TECHNICAL SERVICE BULLETIN NO. 2509

YUGO CLUTCH

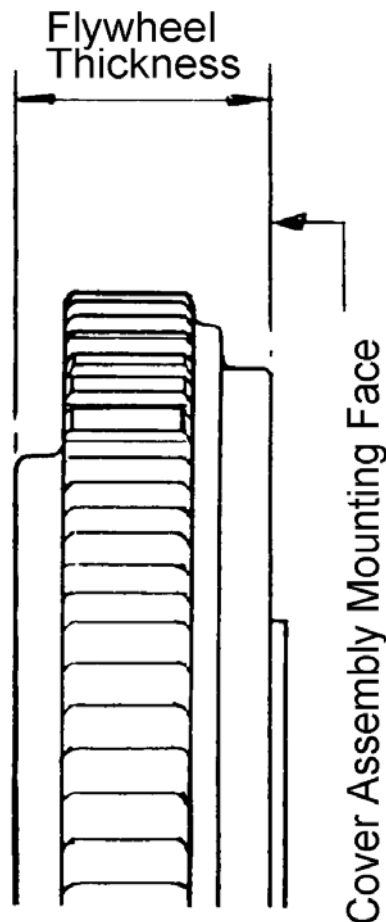
Both the 1100cc and 1300cc engines can now use the standard 1100cc flywheel. It has a thickness of 28mm. (ARI P/N 48-3000)

The original 1300 flywheel, which measured 31mm thick, was fitted on most models produced between 1983 and 1987. Because of the difference in flywheel thickness it is important that the correct clutch assembly is used.

A vehicle with a 28mm flywheel uses clutch set 20-66003. ARI part number 20-66005 clutch set is used with the 31mm flywheel (ARI P/N 48-3001).
